NEC PowerMate® VT 300 Series Celeron™ Processor Information

Processor Jumper Settings

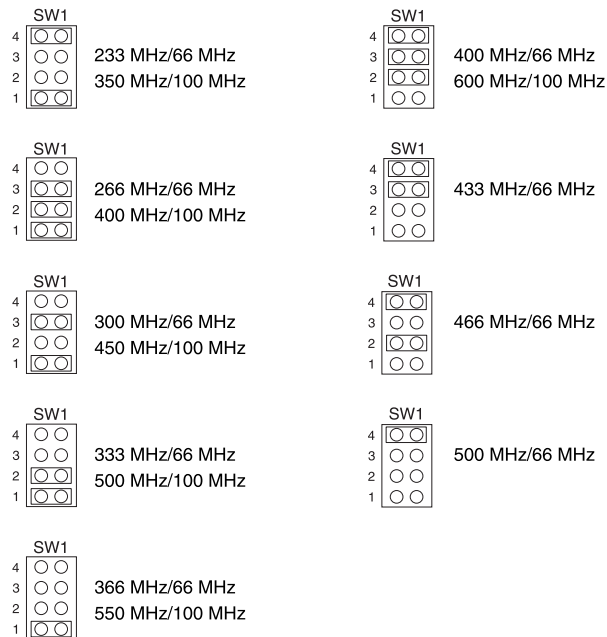
The processor upgrade information in the *NEC PowerMate VT 300 Series User's Guide* is for Slot 1 type Celeron processors and is *not* for Socket 370 type Celeron processors. User-installed upgrades for the Socket 370 type Celeron processors are not supported in the PowerMate VT 300 Series system.

Your version of the *NEC PowerMate VT 300 Series User's Guide* might not contain the jumper settings for the latest 500-MHz and 466-MHz Celeron processors. See the following figure for updated jumper information.

Processor jumpers on the system board are set correctly at the factory. Keep the jumpers at the factory settings.
